WCAP-16793-NP, Rev.0 (Non-Proprietary)
Project No. 694

March 2, 2009

OG-09-84

Subject: Pressurized Water Reactor Owners Group
Responses to the NRC Request for Additional Information (RAI) on WCAP-16793-NP, "Evaluation of Long-Term Cooling Considering Particulate, Fibrous and Chemical Debris in the Recirculating Fluid" (PA-SEE-0312)

_____ SWITCH OVER TIME
 - - - - - BOILOFF RATE
 - - - - - CORE INLET FLOW

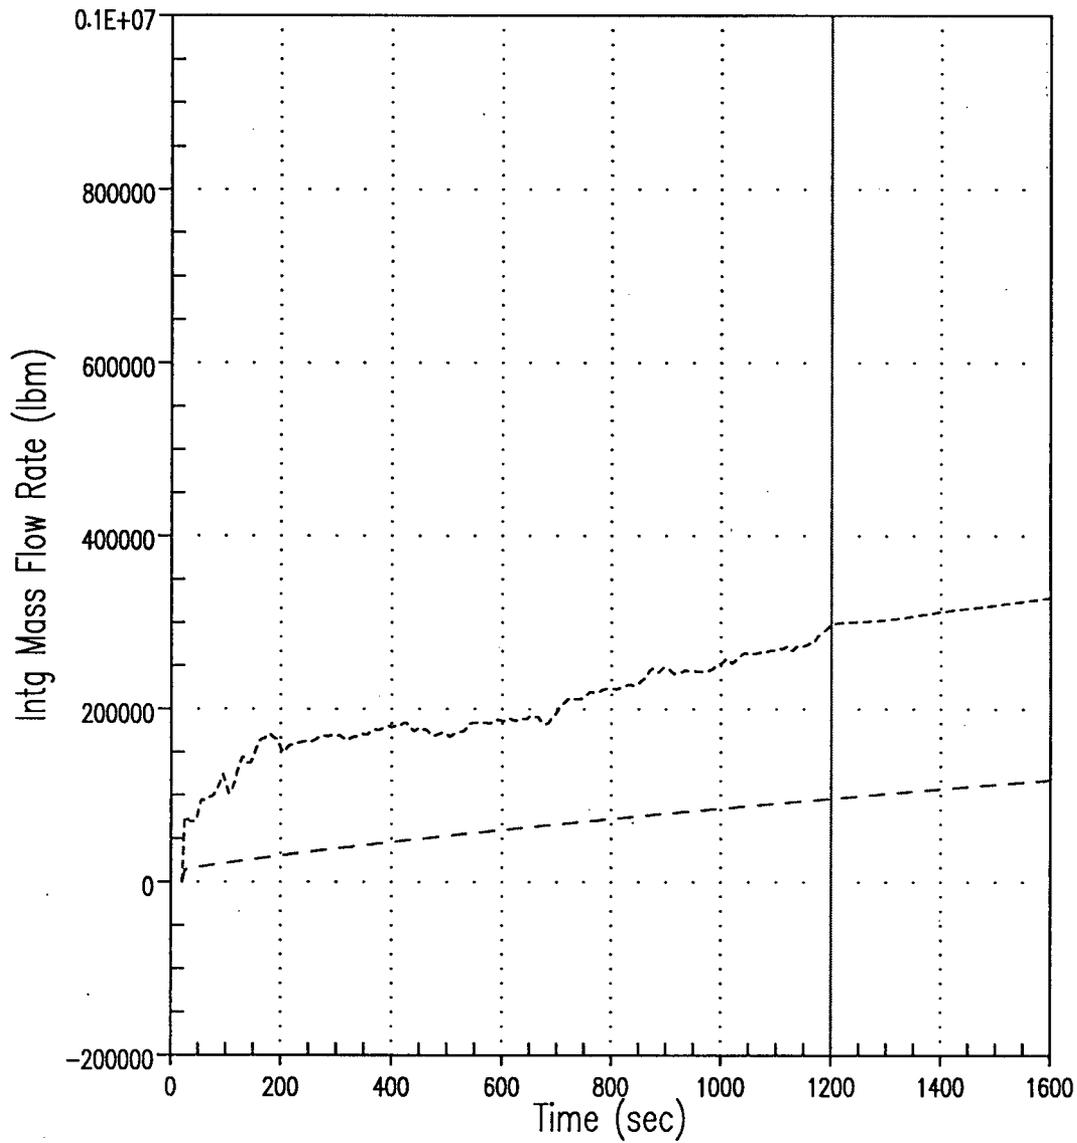
- 1) WCAP-16793-NP, Appendix B, presents analyses of the effect of core inlet blockage using the WCOBRA/TRAC analysis code. Since the report was prepared additional analyses have been performed to determine the blockage level that would reduce core flow below that necessary to match coolant boil-off. Please provide documentation of the additional analyses that have been performed, including figures, for the integrated core inlet and exit flow, peak cladding temperature, core collapsed liquid level, core exit void fraction, and core pressure drop for the bounding conditions. The results should be presented for each case analyzed up to and including the blockage level for which boiloff is no longer satisfied.

The first uniform loss coefficient run performed applied a uniform C_D of 50,000 at the core inlet. The requested plots for this case are shown in Figures 15 through 21. Figures 15 and 16 show comparisons of the integrated core inlet flow and boil-off rate. As shown, even with the increase of the loss coefficient at the inlet, the flow that enters the core is still in excess of the boil-off rate. (Note that the integrated mass flow behavior shown between time $t = 1200$ seconds and time $t = 1250$ seconds of Figure 16 is the result of the 30 second ramp-up of the hydraulic loss coefficient, C_D , to 50,000 that is initiated in the calculations at time $t = 1200$ seconds.) Figure 17 displays the integrated liquid flow at the core exit. The figure displays that liquid in excess of that needed to keep the core quenched enters the core and that liquid flow is present at the top of the core even after the increase of the loss coefficient at the inlet. The PCT is shown in Figure 18. There are no significant PCT excursions after the core inlet loss coefficient is increased. Figure 19 displays the collapsed liquid level of the average assembly core channel (Channel 11 of Figure 6.3.4-3 in Reference 1). The figure shows that the collapsed liquid level drops slightly at time blockage occurs, however, the liquid is maintained even after the increase in the loss coefficient at the inlet. The void fraction at the core exit shown in Figure 20 again illustrates that liquid is present at the top of the core which shows the flow that enters the core after the increase of the loss coefficient occurs is still in excess of the boil-off rate. The core pressure drop is displayed in Figure 21. The figure displays an increased pressure drop of roughly 2 psi as blockage at the core inlet is increased. As the conditions in the Reactor Coolant System (RCS) adjust to increase in core blockage, it is noticed that the core pressure drop fluctuates consistent with the core liquid level.

Figure 1: Survey Results of PWR Sump Screen Fibrous Debris Bypass

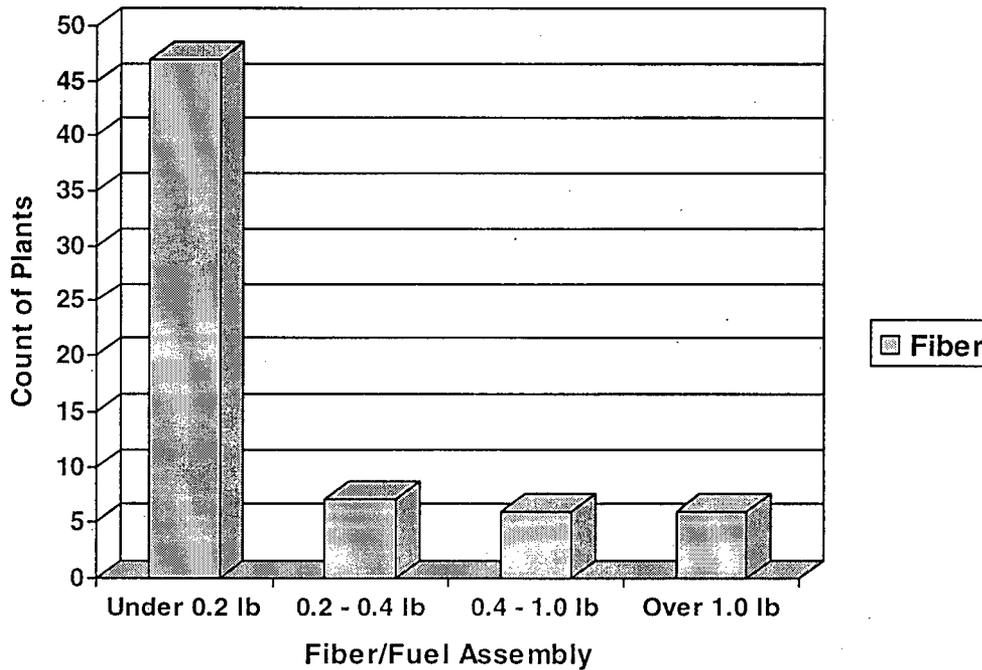
- 5) Please provide data that show the basis for the assumption that fibrous strainer bypass of 1 ft³/1000 ft² of strainer area provides a reasonable estimation of fiber bypass and that use of this number will not affect plant evaluations non-conservatively. Note that some protective fuel filters may be challenged by lower amounts of fiber (i.e. a thin bed) while some may be challenged by higher amounts. Please verify that these data were correlated with the area of the test strainer and that the results were not confounded by extrapolation to strainer areas less than the total of all strainers that may be in service during the event (i.e., strainer bypass estimates should assume all available strainer area is available for bypass).

The assumption of fibrous strainer bypass of 1 ft³/1000 ft² of strainer area has been replaced by considering sump screen fiber bypass mass on a per fuel assembly basis. Total sump screen fiber bypass mass has been provided by licensees through a PWR Industry survey. This licensee-provided information was used to determine the amount of fibrous debris used in fuel assembly debris capture testing. The following chart shows the breakdown of bypass fibrous debris on a per fuel assembly basis for all plants that participated in the survey. The figure takes into account the number of fuel assemblies in the core of each plant reporting sump screen bypass values.

Figure 1: Photograph of the Westinghouse Fuel Test Vessel

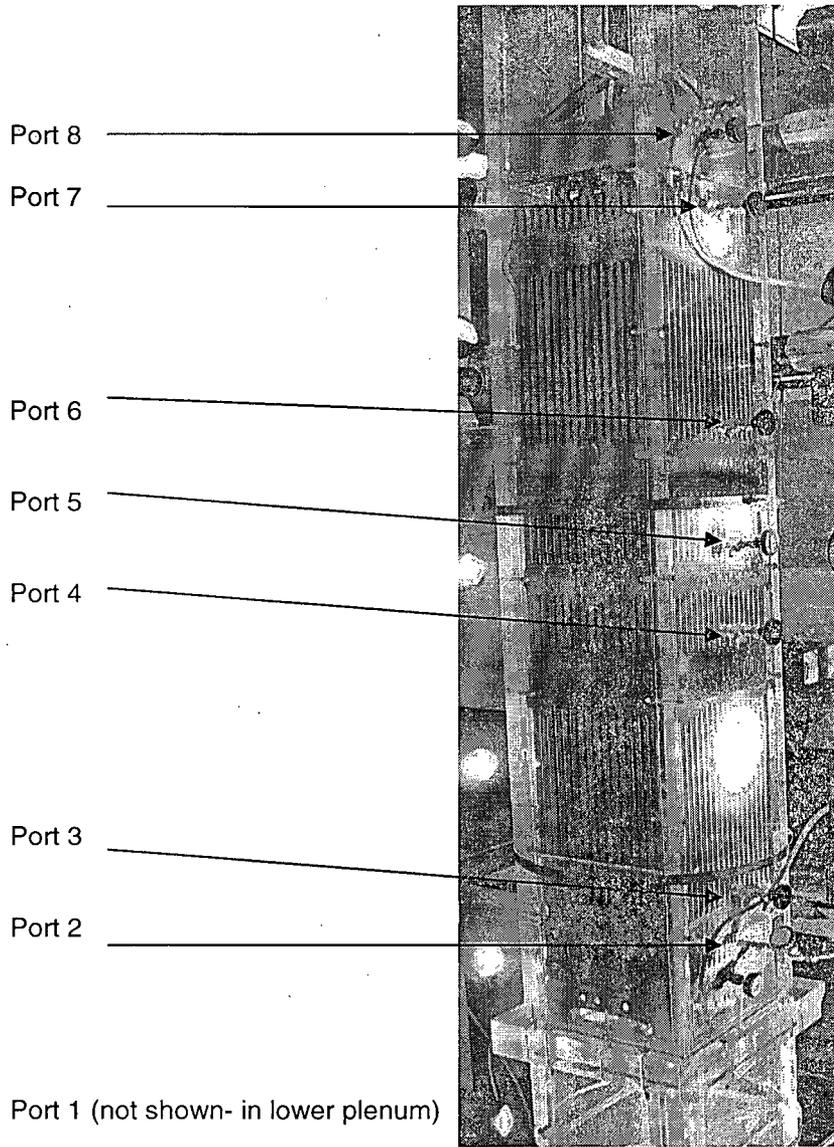
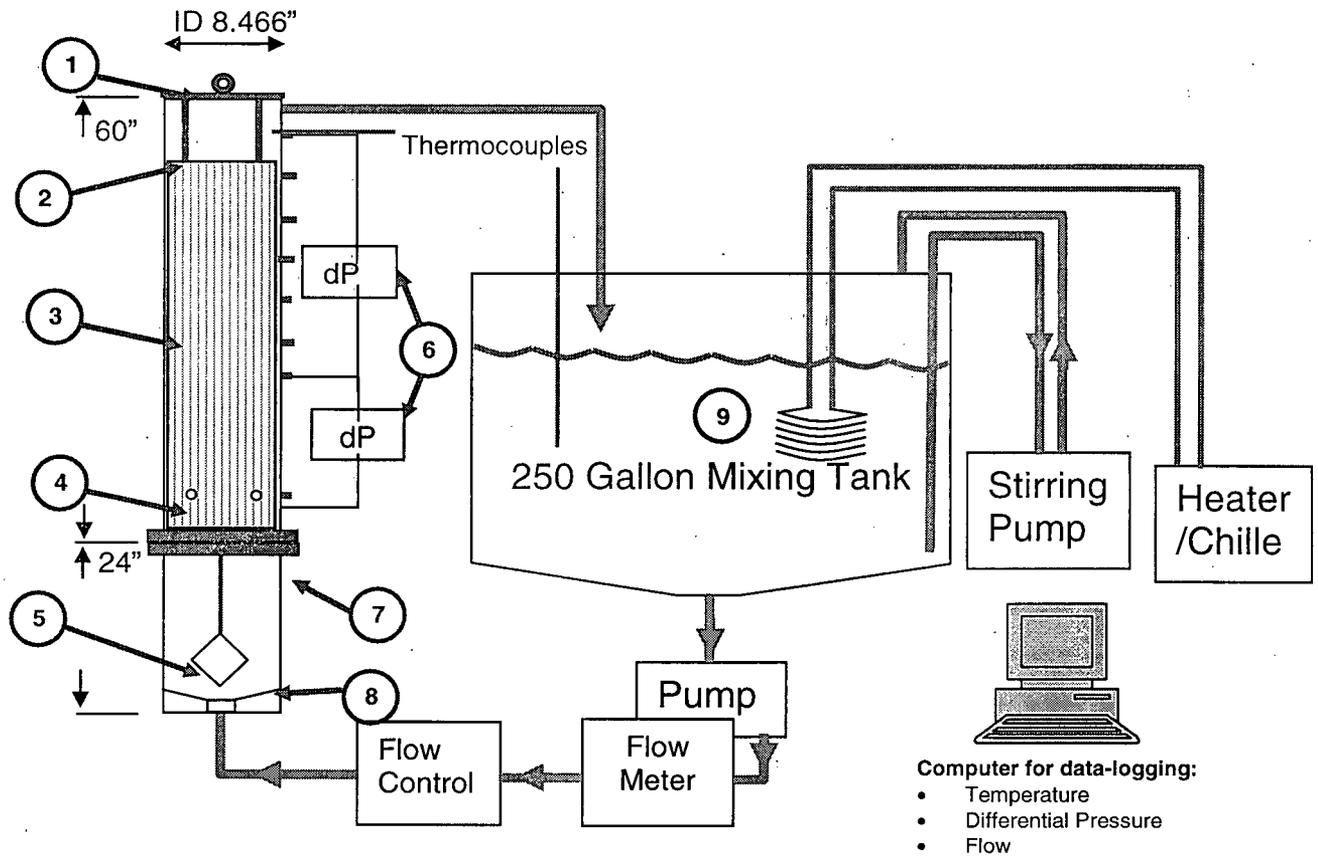
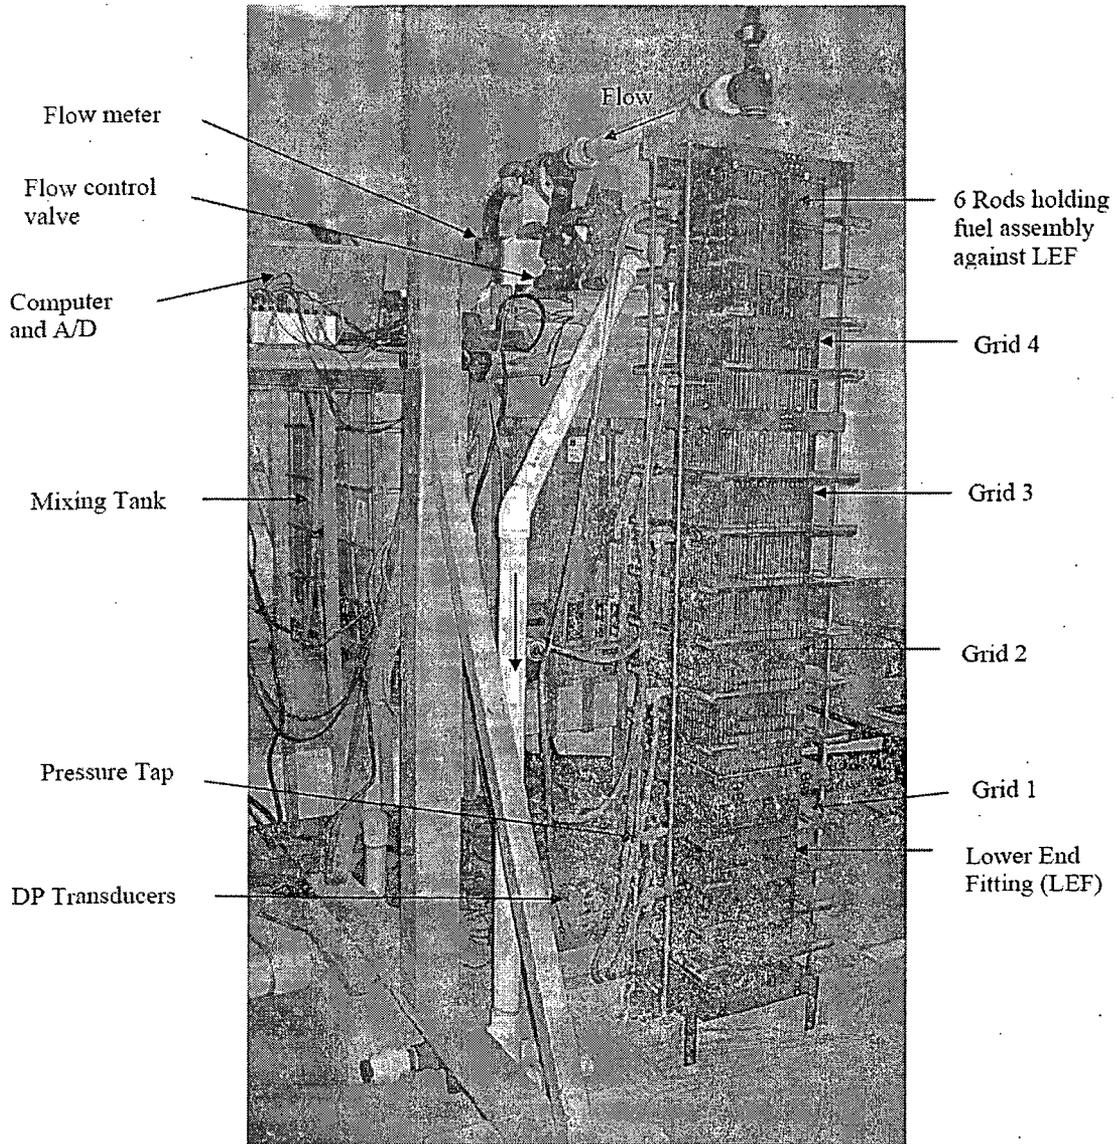
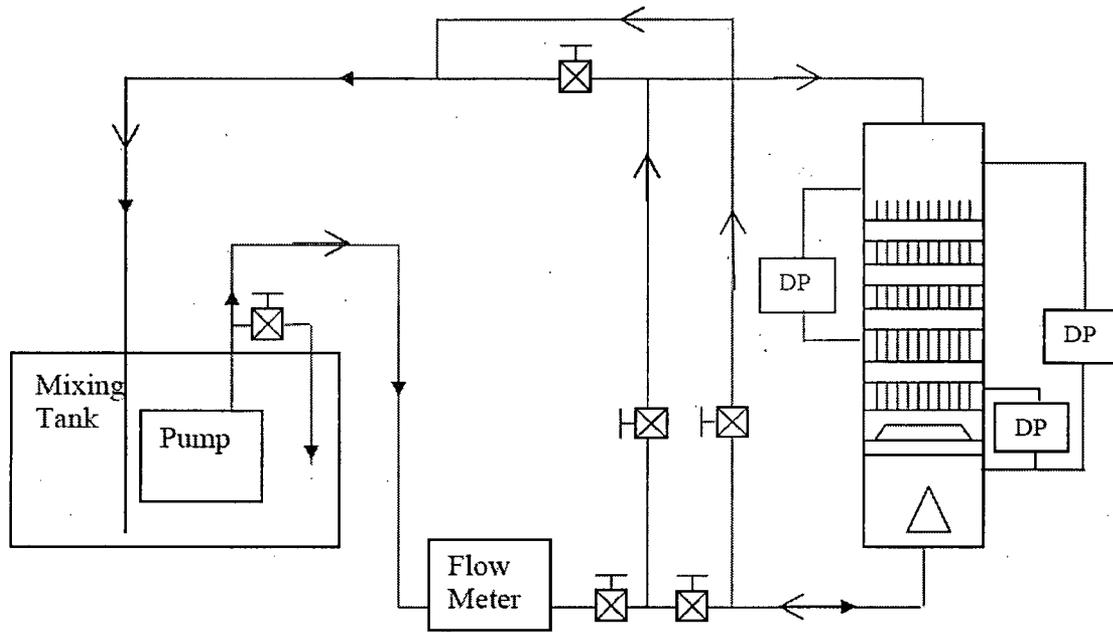
- 6) Please provide the following information for all fuel/core blockage tests that have been sponsored by the PWROG.
- a. flow rates and bases including any variation in the flow rate during testing

The Westinghouse test loop for testing the debris capture characteristics of a full-width fuel assembly is shown in Figure 1. A schematic of this test loop is given in Figure 2. The AREVA test loop is shown in Figure 3. The schematic of this test loop is shown in Figure 4. The test loop is composed of four main parts:
